**TIERRA VISTA UNIT 3 at the TRAILS**  
GRADING AND DRAINAGE PLAN

## PRELIMINARY PLAT FOR TIERRA VISTA UNIT 3 LOTS 1-22, 28-58 TRACTS A-C CITY OF ALBUQUERQUE BERNALILLO COUNTY, NEW MEXICO APRIL 2014

**CITY OF ALBUQUERQUE**  
PUBLIC WORKS DEPARTMENT  
ENGINEERING GROUP  
**TRACT 8 AT THE TRAILS UNIT II**  
GRADING & DRAINAGE PLAN

PLATE 3 G&D PLAN

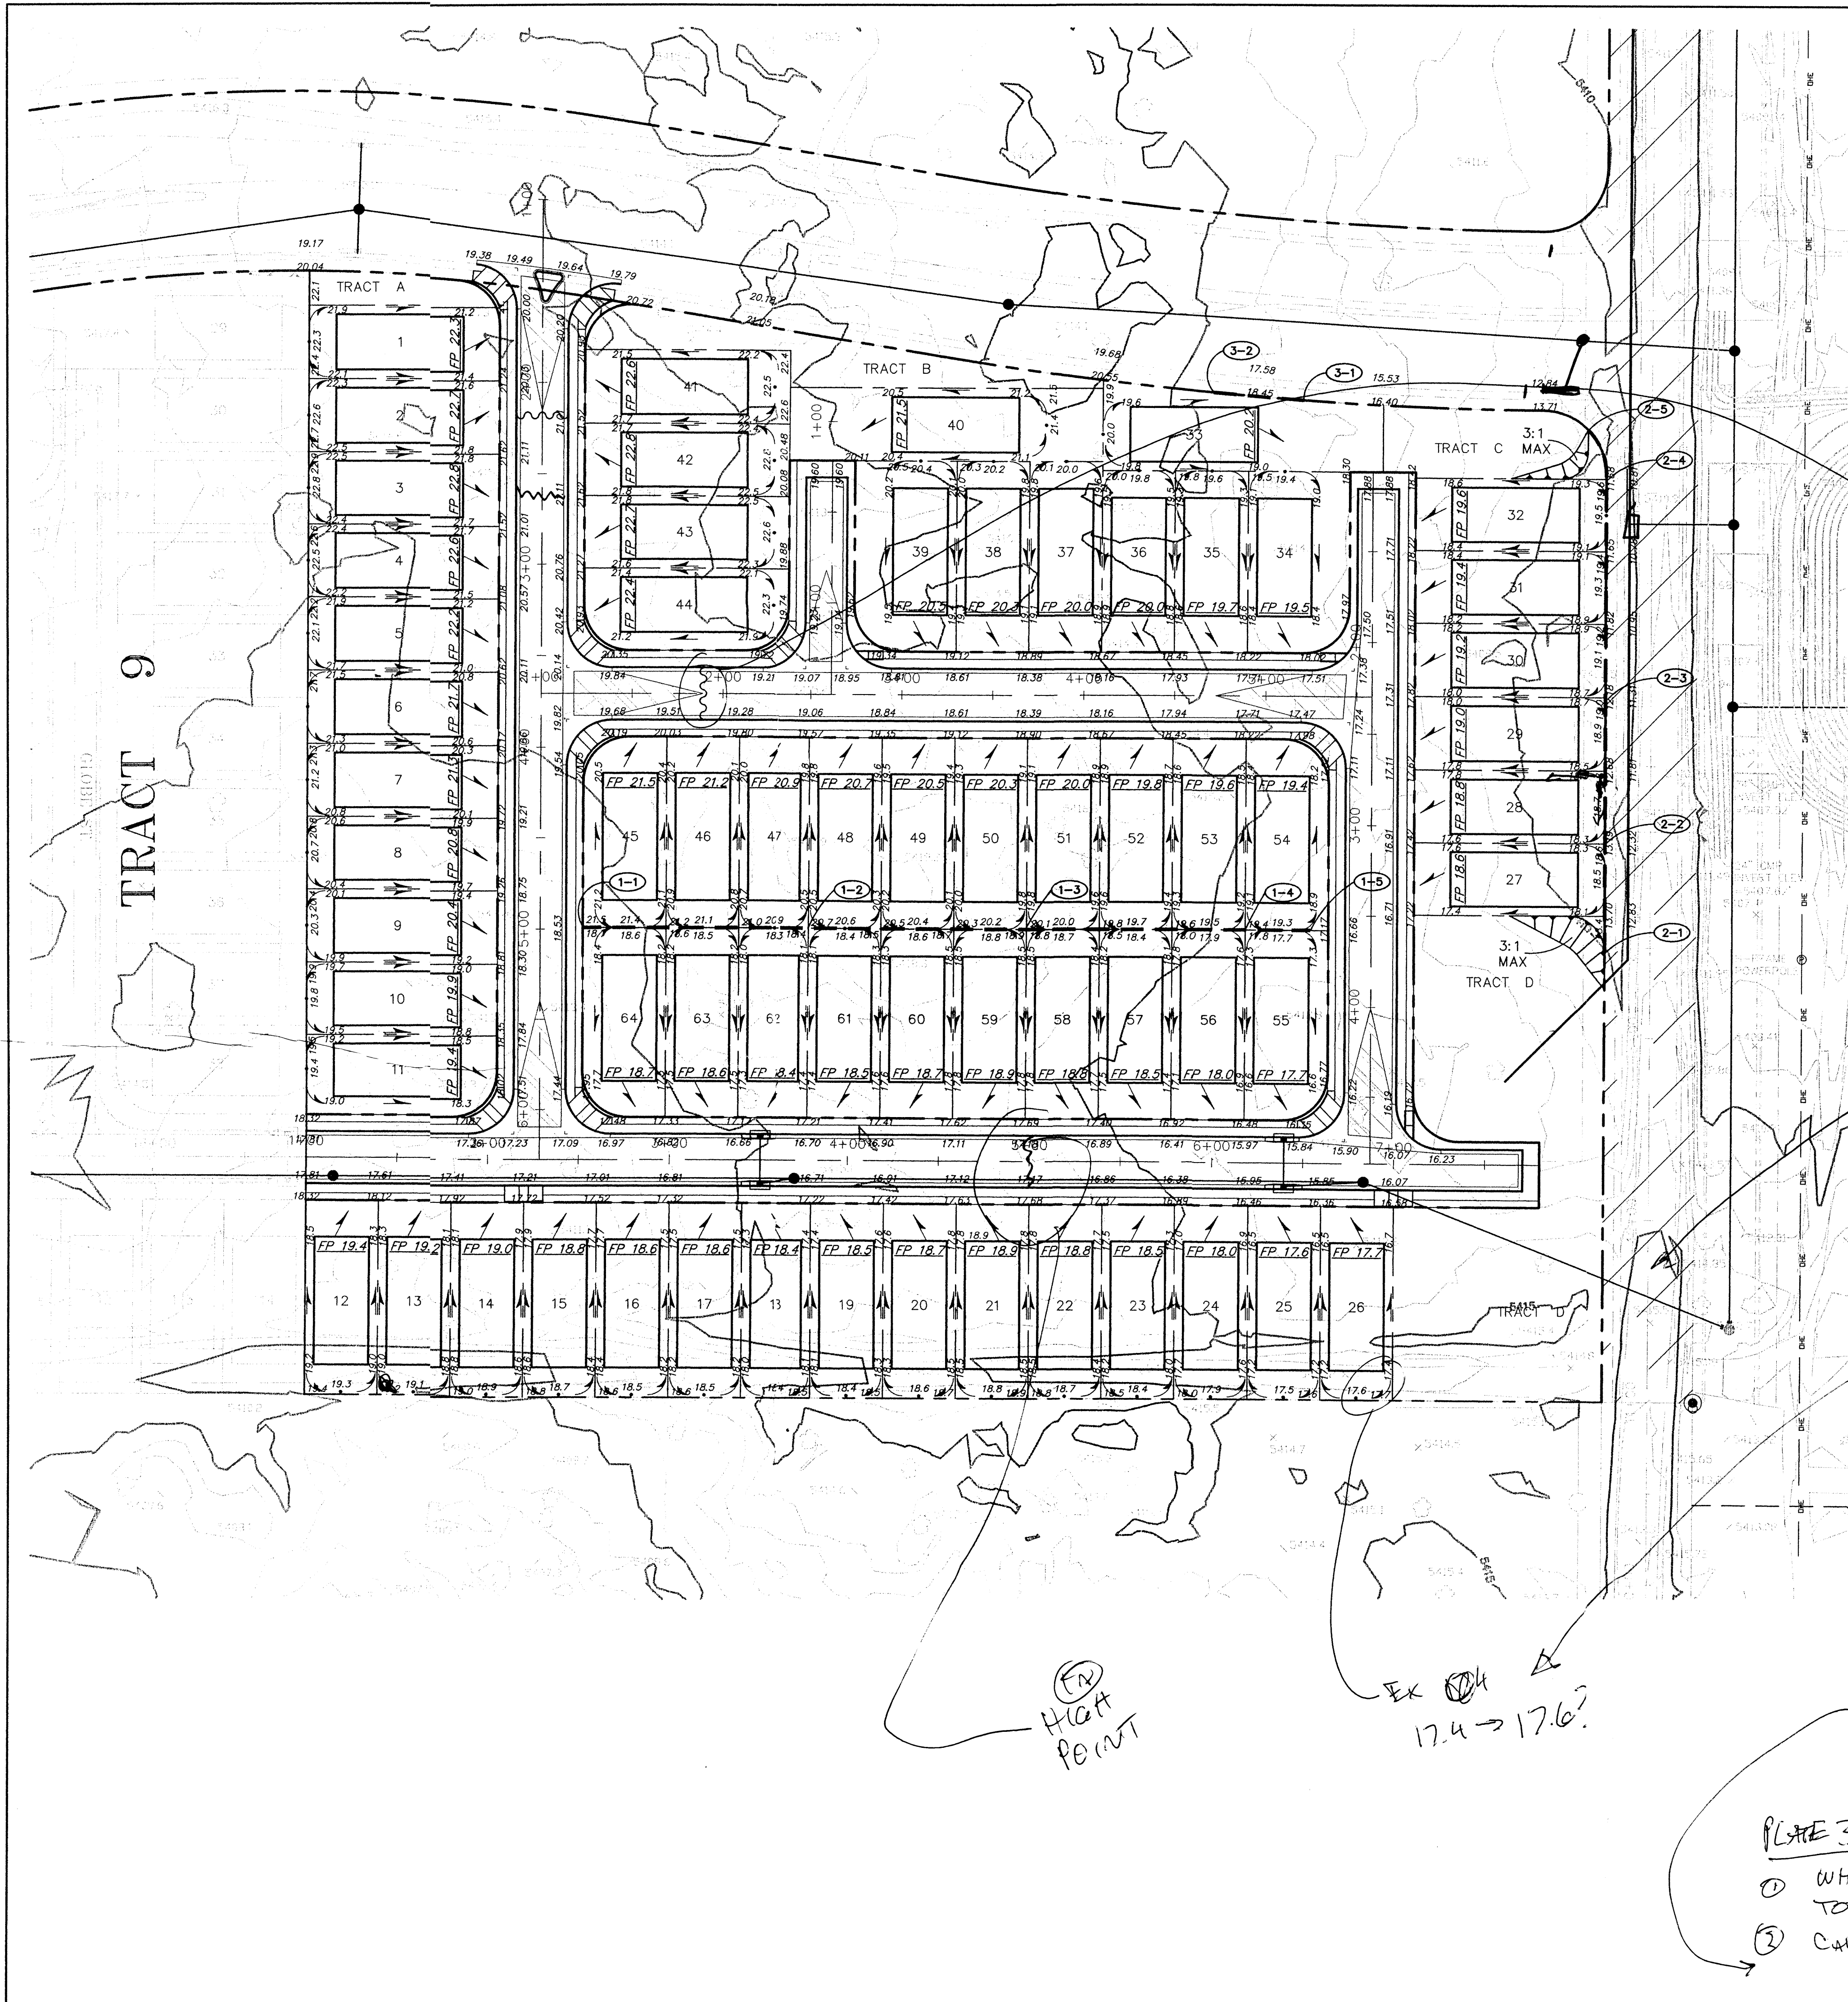
SITE = 9.4 AC.

NARRATIVE: NO BREAKDOWN OF 9.4 AC SITE w/ % TREATMENTS TO VERIFY 27.31 CFS

NOT HIGH POINT

USE CONSISTENT SYMBOLOLOGY

CTG

EASEMENT?

- 1 NOT HIGH POINT! MOVE WEST TO INTERSECTION
- 2 HIGH POINT NOT CALLED AT LOT 21/59 INCONSISTENT LINE TYPE
- 3 BACKYARD FLOWS?
- 4 CTG ON LEGEND
- 5 FLOW ARROW ON LOT 42 POINTS UPSTREAM
- 6 TO HIGH POINT

PLATE 1: INTERIM CONDITIONS

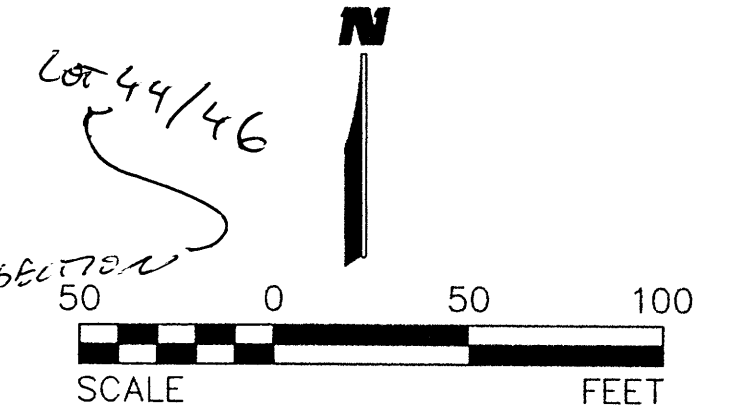
- 1 WHAT DOES "90 DEV (ACRES)" MEAN?
- 2 CALCS OFF: S AREA = 385.12 ACRES "ON HZ" YIELDS 13.06 CFS/AC (NOT!)
- 3 BASIN "D.N - E" NOT SHOWN ON P1 OR P2: ONLY EI ON P1

PLATE 3 = DEVELOPED COND

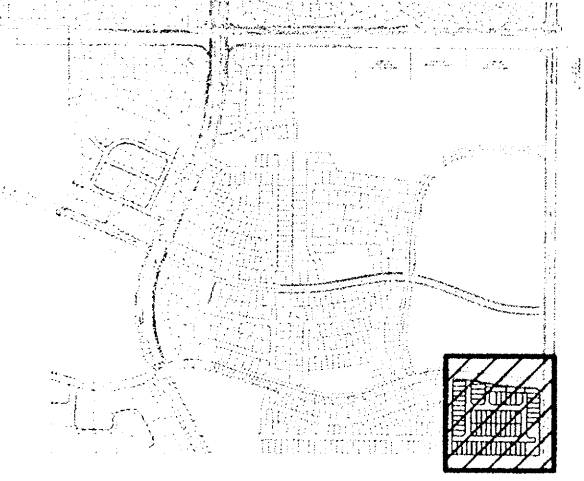
- 1 WHAT HAPPENED TO BASIN 'E' + H3 TOT. AREA = 303.15
- 2 CALCS OFF, BASIN AREAS ON CALCS
